Project:
Gilham Elementary School
Asbestos Abatement Remodel Project 2021
CIP # 260.193.50919.003

ISSUED BY: Doug Lemonds
Eugene School District 4J
Facilities Management
715 W. 4th Ave.
Eugene, OR 97402

Date: January 5, 2021

A-1

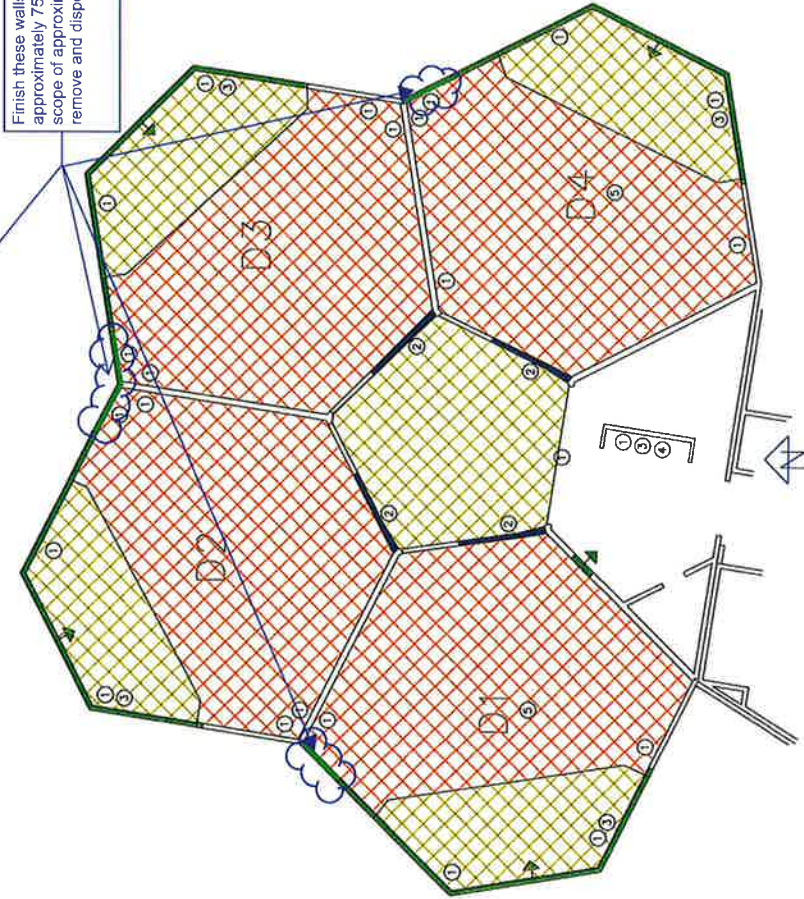
3.0 Asbestos Abatement Drawing A-1

Delete: 2,120 sq. ft. of asbestos containing wall material-General Notes & Abatement Notes

Add: 2,380 sq. ft. of asbestos containing wall material-General Notes & Abatement Notes
Additional wall removal areas located on drawing
